## Technical Service Bulletin

TBJ004

**Product:** TT\* and TS\* units with 208/230 & 265 single phase voltage

**Effected Range:** serial number K108\*\*\* – K115\*\*\*, shipped March 5, 2007 – April 12, 2007

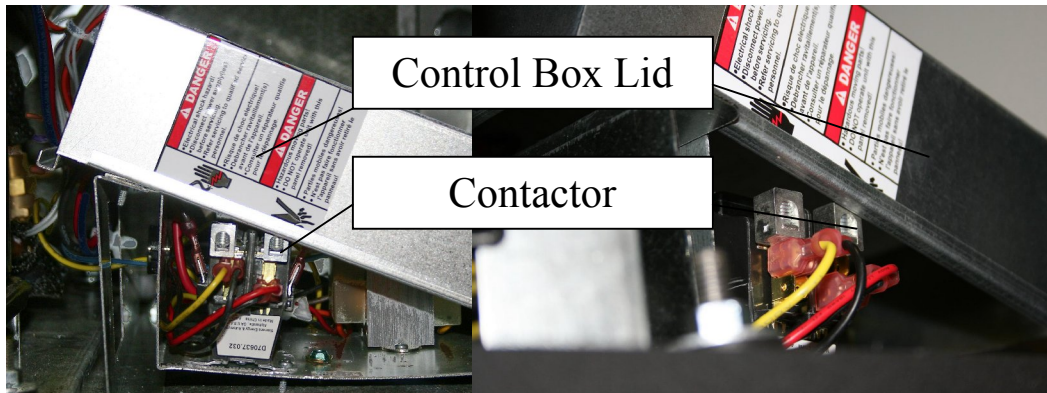
**Issue:** The contactor's supply voltage terminals are located too close to the control box lid and may cause the unit to short to ground. See pictures below.
